<b>Technical Service Bulletin Number</b>	<b>Revision Level</b>	<b>Date</b>	<b>Group Number</b>
TSB130182

PACCAR™ Chassis with 2013 CM2350 Heavy Duty and MidRange Engines Setting Fault Codes 1921, 1922, 1981, 3375, and 3376.

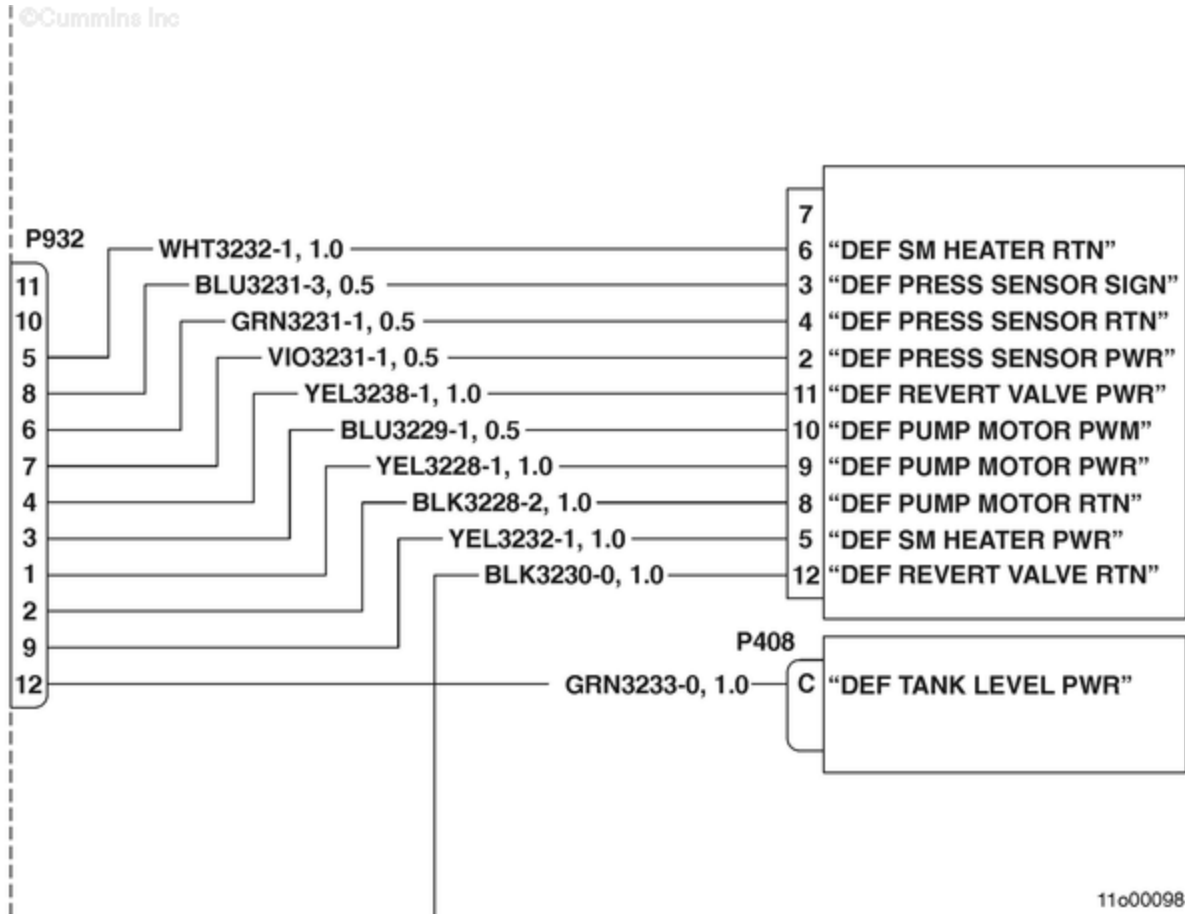
The illustration below depicts the wires in the wrong locations. The green wire (GRN 3231) should be located in the number 4 connector cavity. The white wire (WHI 3232) should be located in the number 6 connector cavity.

Relocate the wires in the connector. The green wire should be inserted in cavity number 4. The white wire should be inserted in cavity number 6.

4. Disconnect the DEF tank harness from the DEF supply module. PACCAR™ nomenclature for this harness is the DEF tank harness. Examine connector pins 4 and 6. Pin 4 should be a green wire and Pin 6 should be a white wire. If the pins are incorrect, swap the pins at the DEF supply module connector. Connector P931 (below) shows the **correct** pin outs for pins 4 and 6.
